SB-10043466-3138

Title: MaxxFORce 11 and 13 – Special Fuel Rail Kit

Applies To: Specific Serial numbers within the range 125HM2Y4100013 and 125HM2Y4101731, see attached for further clarification **Vehicle – Models, MY2010 – includes – excludes - engines and features. Built From 7/21/2010 To 8/15/2010**

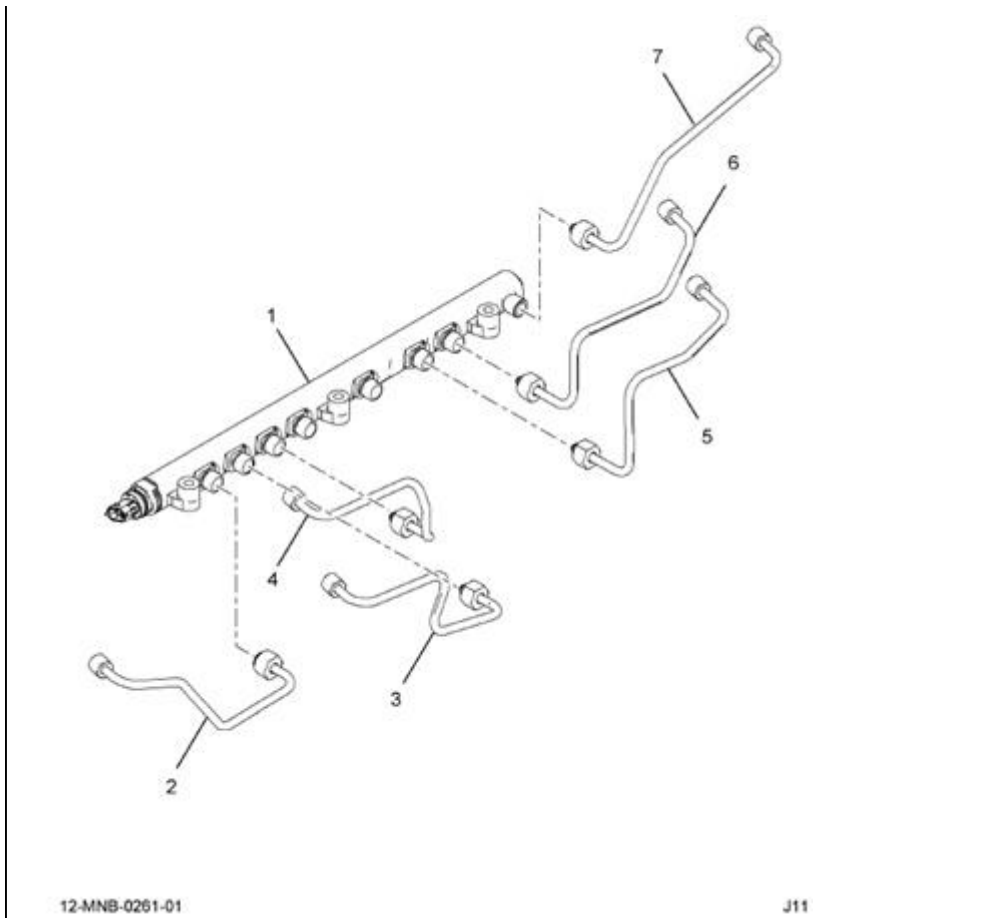
Engines with serial number listed below were build with Fuel to Rail tubes that are excessively hard. During initial installation, these tubes may distort the fuel rail making a replacement fuel to rail tube not seat properly. When replacing any fuel to rail tubes (items 2 - 7) on one of the affected vehicles (listed below), the following kit should be used, 3014634C91. Subsequent repairs to tubes or rails should be done as directed in the service manual.

3014634C91 FUEL RAIL AND TUBE KIT, SPECIAL

Item	Part #	Description	Qty.
Kit	3014634C91	FUEL RAIL AND TUBE KIT, SPECIAL	1
Kit Contents			
1	3006765C91	RAIL ASM, FUEL	1
2	3012753C2	TUBE HI PRESS RAIL TO INJCTR 1	1
3	3006042C2	TUBE HI PRESS RAIL TO INJCTR 2	1
4	3005678C2	TUBE HI PRESS RAIL TO INJCTR 3	1
5	3005679C2	TUBE HI PRESS RAIL TO INJCTR 4	1
6	3012757C2	TUBE HI PRESS RAIL TO INJCTR 5	1
7	3012758C2	TUBE HI PRESS RAIL TO INJCTR 6	1
